Public Input No. 3085, Assigned to Code-Making Panel 1, Refer to Code-Making Panels 2 - 18

Public Input No. 3085-NFPA 70-2023 [Global Input]

Public Input No. 4050, Assigned to Code-Making Panel 10, Refer to Code-Making Panels 1 - 9 and 11 - 18

Informational Note Figure X50.100(B)(1) Illustration of a Bonding Conductor in a Communications Installation Equipped with an Intersystem Bonding Termination or Terminal Block Providing Access to the Building Grounding Means.

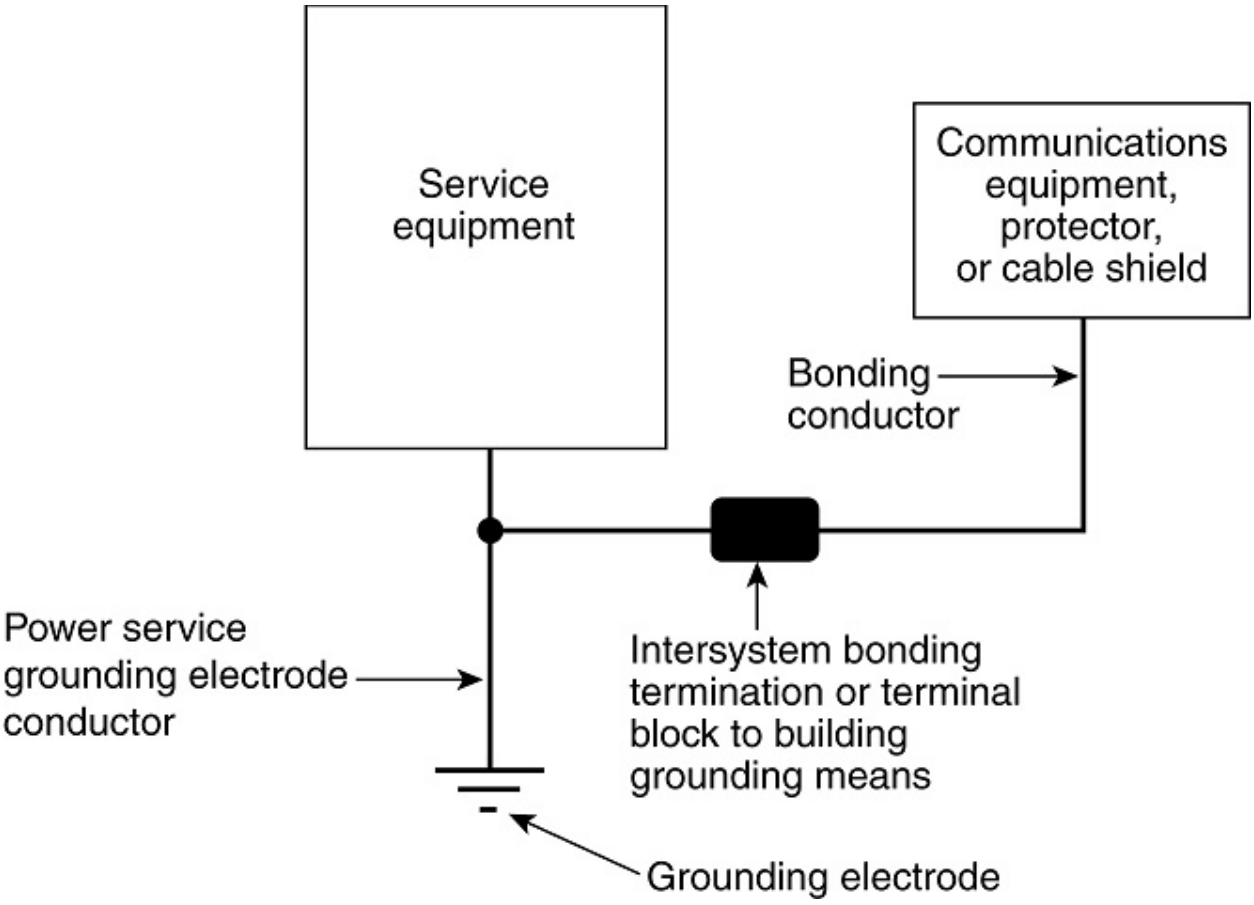
> Informational Note:
> Informational Note Figure X50.100(B)(1) illustrates the connection of the bonding conductor in buildings or structures equipped with an intersystem bonding termination or a terminal block providing access to the building grounding means.

Informational Note Figure X50.100(B)(2) Illustration of a Grounding Electrode Conductor and a Bonding Conductor in a Communications Installation Not Equipped with an Intersystem Bonding Termination or Terminal Block Providing Access to the Building Grounding Means.

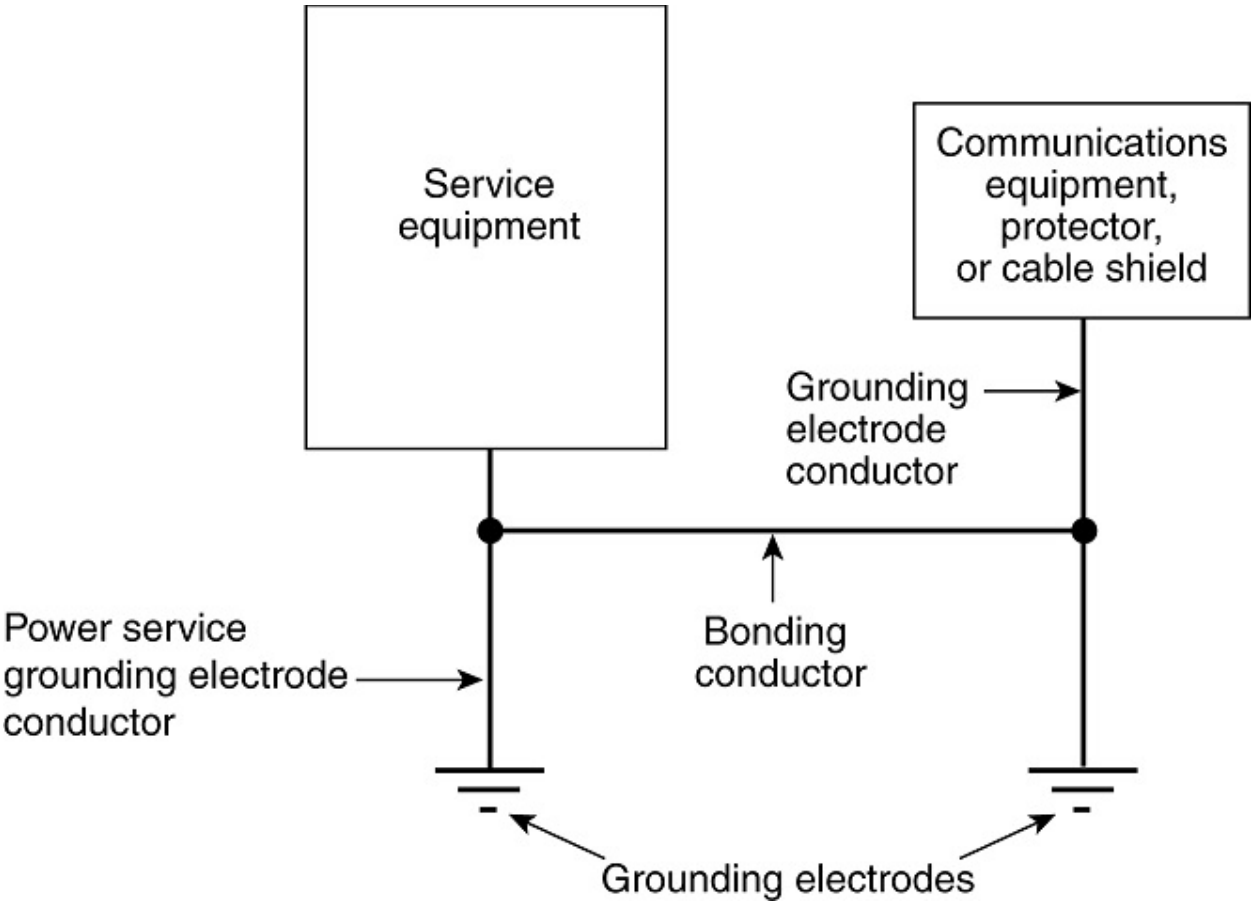
Informational Note:
See Informational Note Figure X50.100(B)(2) for an illustration of a grounding electrode conductor and a bonding conductor in a communications installation not equipped with an intersystem bonding termination or terminal block.

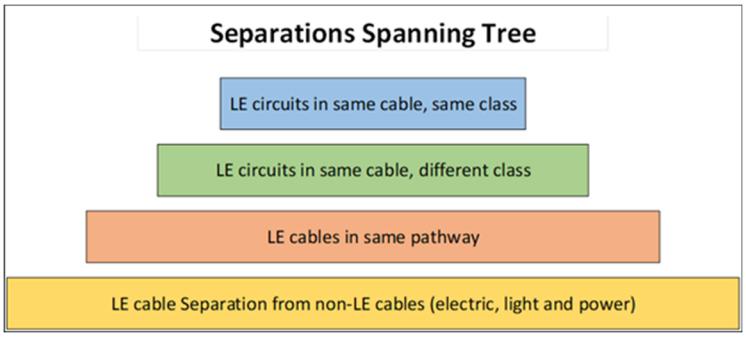
The structure of X00.100 follows the following hierarchy:

- X00.100 (A) is the blue block
- X00.100 (B) and (C) are the green block
- X00.100 (D) and (E) are the salmon block
- X00.100 (F) (G) (H) (I) are the yellow block

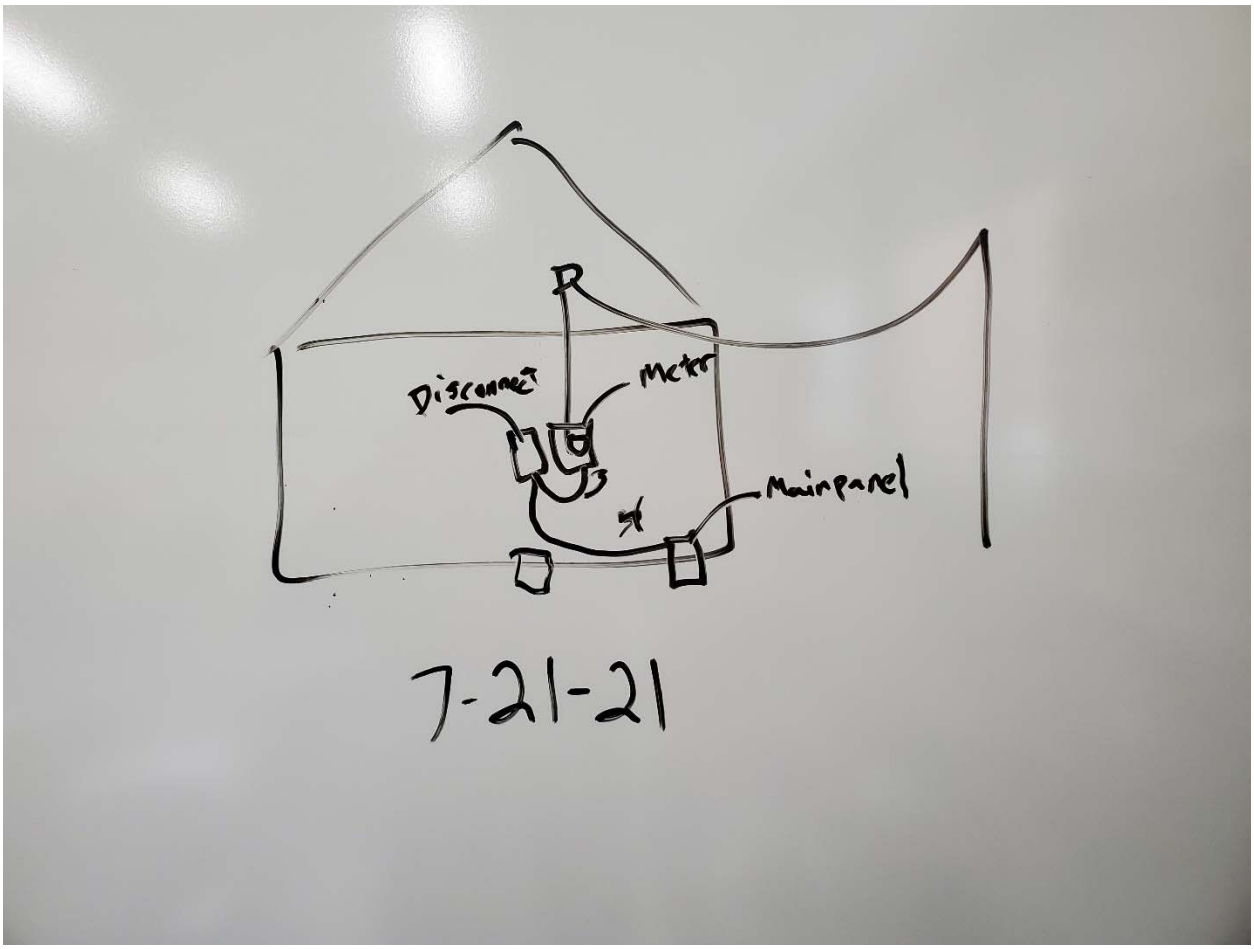
The above drawing was presented to the code change submitter with a question; Where do I make the main bonding connection, at the main panel or the service disconnect?

The question came from a state licensed journeyman electrician with more than 8 years' experience in the electrical industry. The journeyman made the drawing on a whiteboard.

The drawing shows the meter enclosure on the exterior of the house, with the disconnect, main panel, and sub panel all in the house. The 3-conductor cable between the meter can and the disconnect is because the serving utility will not allow an equipment grounding connection inside the meter enclosure.

The journeyman was questioning the bonding location for two reasons:

Resolution: The committee affirms that the word choice of Main to indicate the bonding conductor at the service is well established. The panel sees that a more thorough review of the NEC along with other codes and standards regarding the use of the term and its derivatives must be performed. Based on the amount of time involved in such a review this comment is held in accordance with 4.4.8.3.1(C) of the regulations.
